## **EAGLE GOLD HEAP LEACH FACILITY AND CYANIDE MANAGEMENT REVIEW**

**ENERGY, MINES & RESOURCES, YUKON GOVERNMENT**

JULY 2022

PROJECT 4667

Figure 4-1: ADR Infrastructure Layout

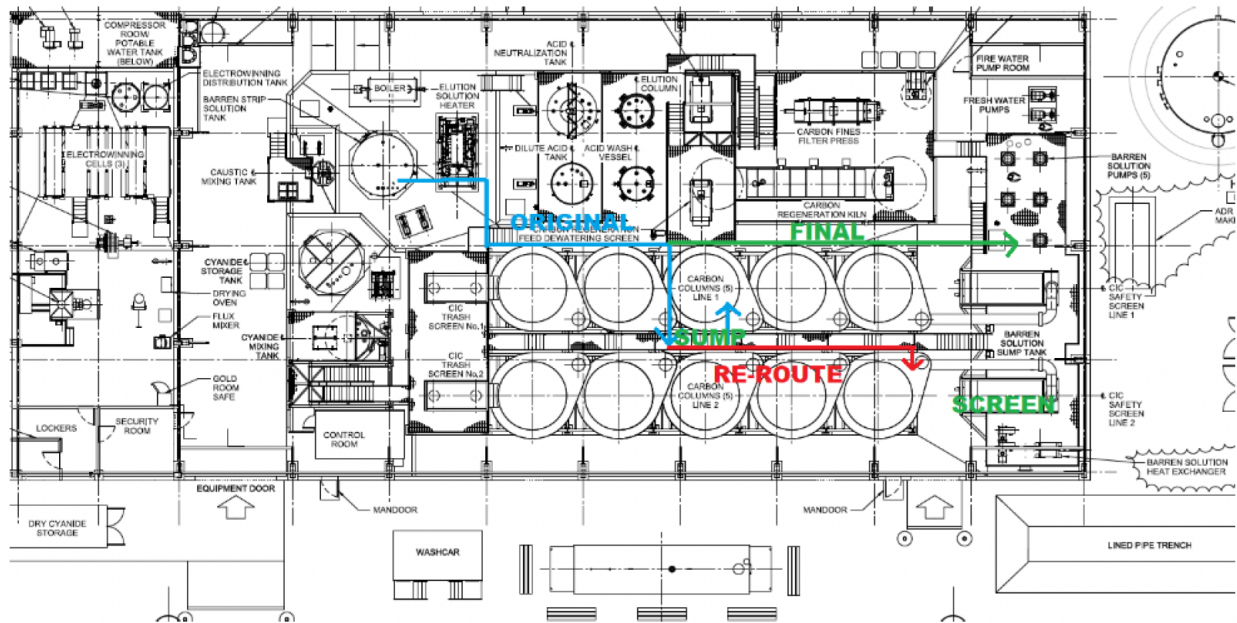
There was a process solution release from the ADR plant on 22 June 2021 (Eagle Gold Project Spill Report, July 2, 2021). This was the third reported spill but the first related directly to the ADR plant. The Root Cause analysis presented in that report identified as the primary root cause *"a change in the routing of process solution, which enabled the introduction of warm caustic barren strip to the tail end of the south CIC train."* This, in turn, contributed to the formation of precipitate which blinded the fine discharge screens and allowed process solution to overflow onto the ADR plant floor and, ultimately, exit the plant through the ADR southeast bay door (see Photo 1, below, which is an excerpt of Photo 2-1 of the referenced spill report). Figure 4-1, also from that spill report (reproduced below), shows the original and re-routed flows.

Since moving pipes and clogged screens are common in ADR plants, this does not seem to address the actual root cause. The area where the spill occurred was within the ADR plant, but the containment was inadequate to hold this spill. This is in contrast with Section 4.1 of the Forte report (page 14) which states “Any spillage within the ADR plant are contained within the process plant containment.” Since any part of an ADR plant can be exposed to process solution the primary root cause is the lack of adequate containment, which was missed in the audit.

2.1a: The ADR plant should be retrofitted to provide adequate containment as described in the CMP and the ADR Plan, or otherwise as intended by the Cyanide Code and best industry practices. This retrofitting should include measures adequate to ensure full containment. The retrofitting as envisioned in this recommendation should be relatively minor work. This should be completed in 2022.

2.1b: The CMP and ADR Plan should be updated to reflect current conditions.

2.1c: The next audit of the CMP should include a site visit, thorough reconciliation of as-built conditions with the design, applicable plans, and license requirements.

Figure 4.2-1: Cyanide Storage and Mixing Area Containment

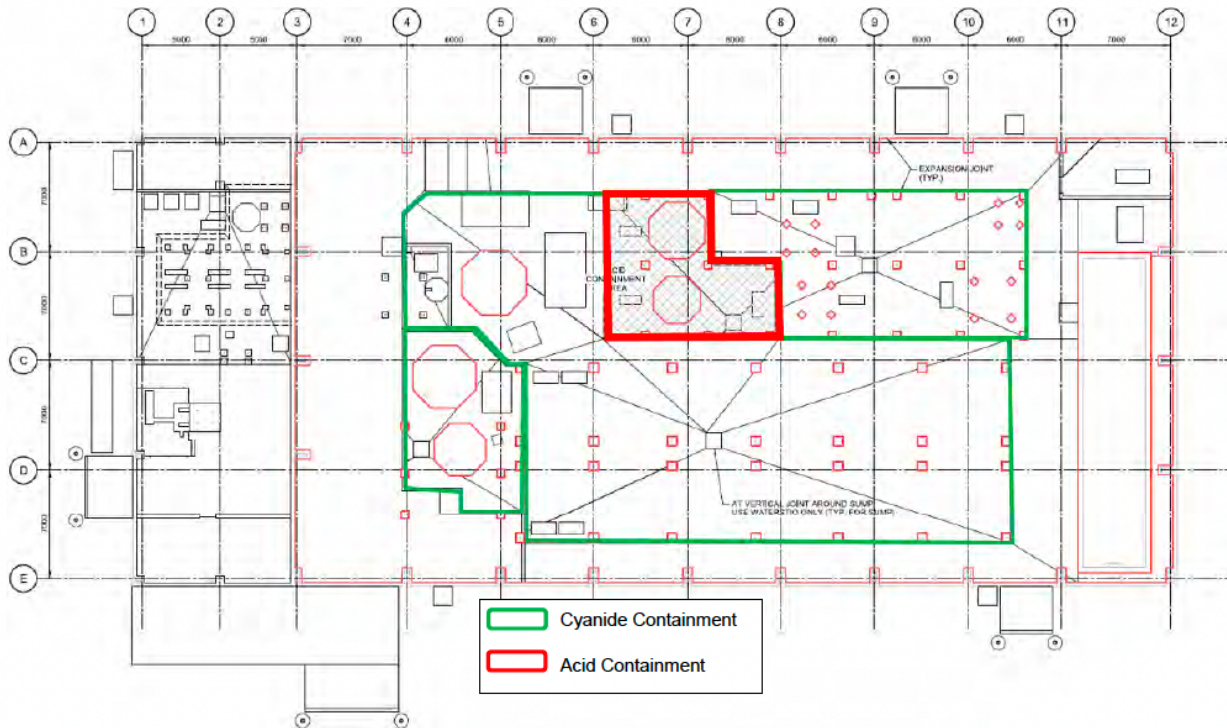
Figure 4.2-1 of the CMP (reproduced below) shows the area of “cyanide containment” as essentially the entire ADR plant (the green outline) including the area of the spill. Section 5.7.5 states “Process solution pipelines within the ADR area are all installed within concrete secondary containment. All barren solution risers and distribution lines will be placed within the lined footprint of the HLF, thus any potential leakage is captured within the pad, ultimately reporting to the In-Heap Pond. The pregnant and barren solution pipelines to the HLF riser arrangements and associated pumping stations that do not drain directly to the HLF impoundment will be placed in lined trenches, with any leakage, stormwater, or snowmelt accumulation in the liner system reporting to either the HLF impoundment.” Section 2.2 of the ADR Plant Operations Plan (ADR Plan) (StrataGold, March 2019) states “Beyond concrete containment with the building, The ADR Plant itself rests on pad also designed for cyanide containment. The pad underneath the building is lined and graded such that overflow would be directed into a lined trench that flows back into the Heap Leach Facility (Figure 2.2-2).” Figure 2.2-2 of the ADR Plan is also reproduced below.

Section 4.2 (Contributing Factors) of the spill report states “Two main site factors have been identified that contributed to the subsequent release of process solution outside of ADR containment: 1) ADR containment design considers only overflows from defect or damage to the tankage within the ADR (as is common for secondary containment design), 2) pad and road

grading allowed process solution to escape containment rather than flow to the heap pad.” Item #1 accurately represents the as-built condition of the ADR plant but is inconsistent with the Forte report, the CMP, and the ADR Plan. Importantly, items 1 & 2 are not in compliance with Cyanide Code Standard of Practice 4.1, which states “Implement management and operating systems designed to protect human health and the environment including contingency planning and inspection and preventative procedures.” That is, since the ADR plant can have process solution anywhere, the plant should include full secondary containment. Further, any potential escape routes from the in-plant containment should be directed towards external containment.

Figure 5.3-1: Site Water Balance Model

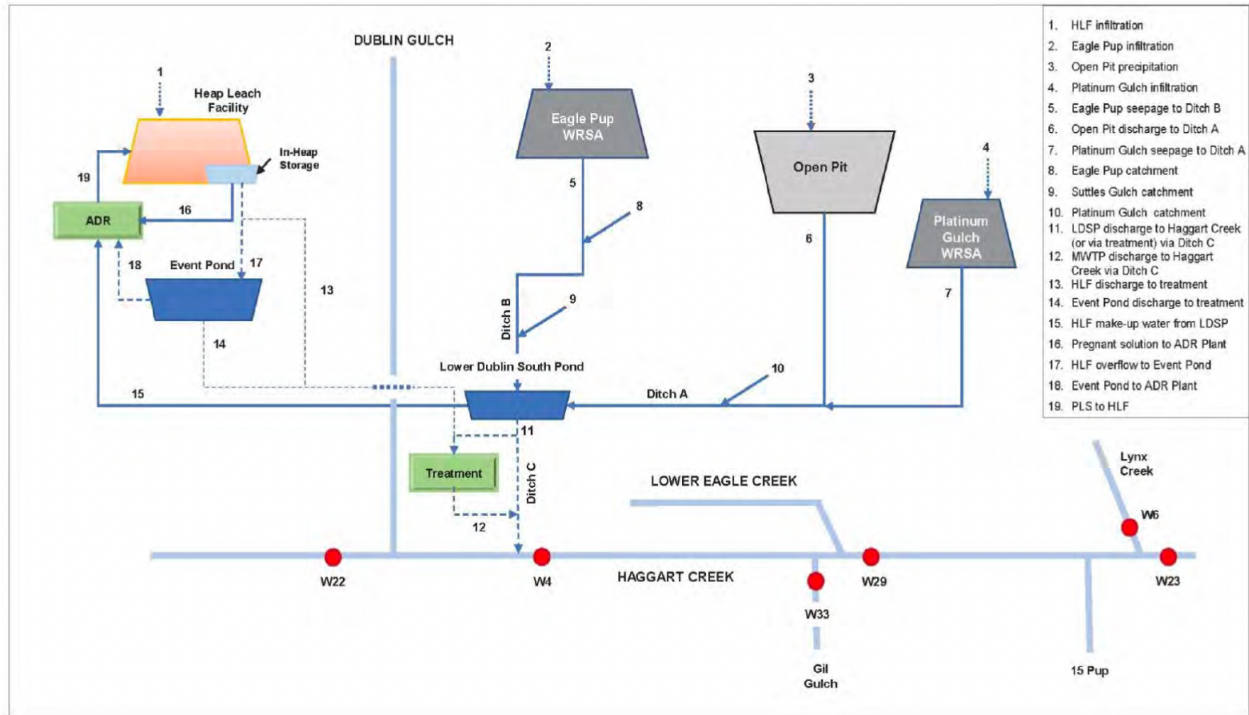
The water balance model is the subject of a separate technical memo, but since water balance management is discussed in the CMP (Section 5.3), some specific related issues are pointed out here. This section includes a schematic of the model as Figure 5.3-1, reproduced below. However, there is an important connection missing: water from the Lower Dublin South Pond (LDSP) is periodically pumped to the Events Pond (EP) to avoid discharging non-compliant water from the LDSP. Surplus surface water thus accumulated in the EP is occasionally discharged from the process circuit without treatment (i.e. #14 of Fig. 5.3-1, but not to treatment). Neither of these flows are reflected in the water balance model and that has contributed to extended periods of infringement on the Desired Available Storage (DAS) in the Events Pond during 2020 and 2021. A minor issue is that the diagram identifies the flow from the ADR to the HLF (#19 of Fig. 5.3-1) as "PLS to HLF." This is not usually PLS but rather barren solution.

The transfer of solution from the LDSP to the EP is contrary to the language of CMP Section 5.4.1 Prevention Measures for Open Ponds, which states "*The Events Pond will be maintained empty except to contain and temporarily store exceptional rainfall events or overflows from the in-heap pond.*" However, such exclusiveness in terms of use of EP is in the context of protecting wildlife, and so long as the EP has never been used to store process solution the risk to wildlife from these transfers should be minor.

2.3a: Update Sections 5.3 and 5.4 of the CMP, including Figure 5.3-1, to reflect the current water management system, including flows directed from the LDSP to the EP and discharges from the EP. This should occur with the next CMP update.

2.3b: Protocols should be developed for transfers of storm water to the EP to verify that there is no cyanide in the EP so that the intent of Section 5.4.1 is not violated. This should be revised in the next CMP and EMSAMP updates.
